Re: Responses to Preliminary/Final Land Development Plan Comments
LCBC Church
1400 Church Road
Manchester Township, York County, PA
SDC# 1590.1

Re: LCBC Church-1400 Church Road
Preliminary/Final Land Development Plan
Manchester Township Plan #2025-12
Engineer's Project No. 0841.3.12.53

PRELIMINARY/FINAL LAND DEVELOPMENT PLAN PROPOSED HOUSE OF WORSHIP

STORM SEWER PROFILES

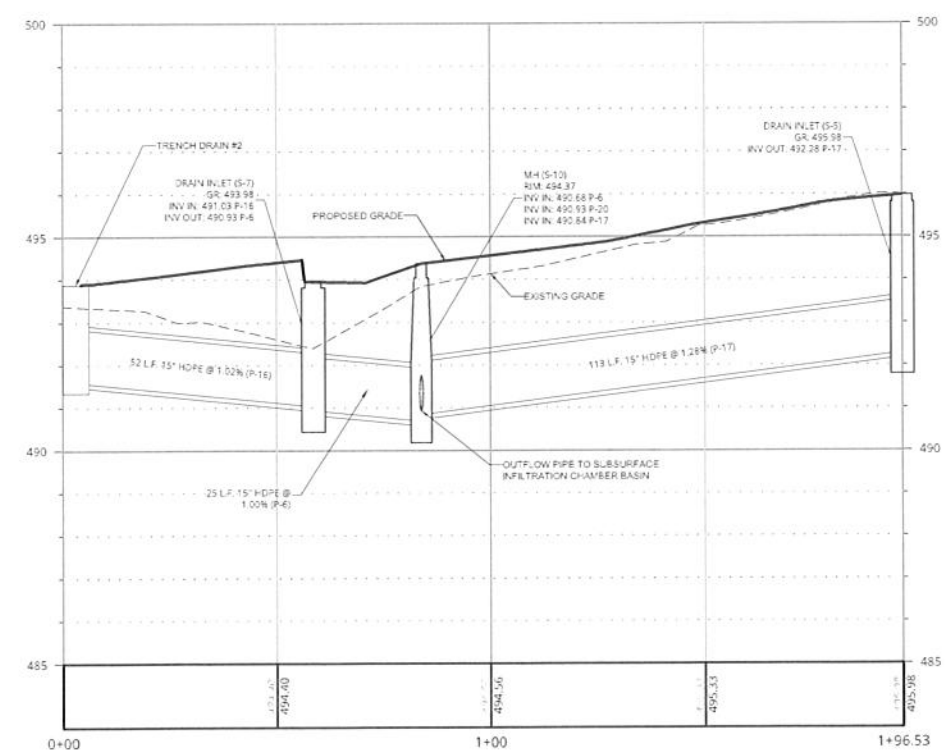
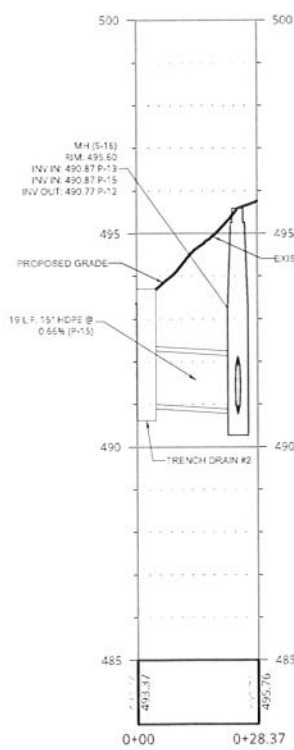
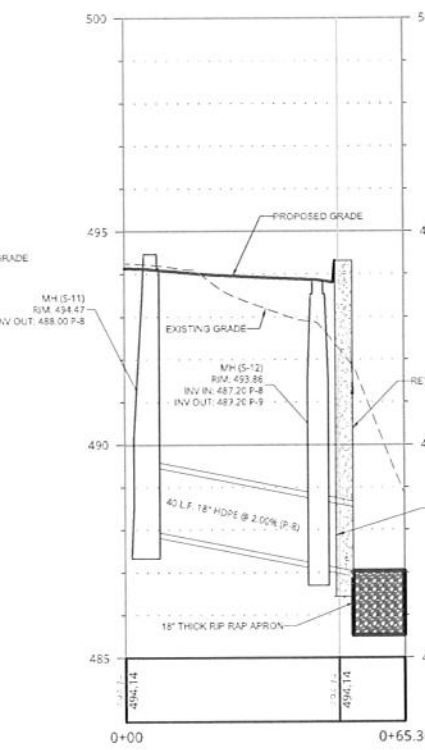
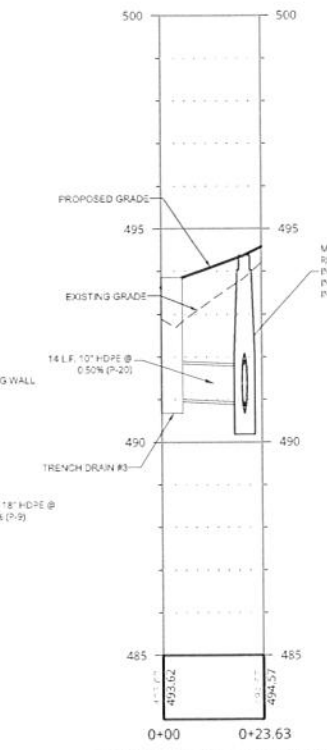
12. Profiles for all proposed storm sewer shall be included within the plan set. (§22-406.4.43)
Response: Profiles of the proposed storm sewers throughout the site have been prepared and incorporated into the plan set as Sheet 4.01.
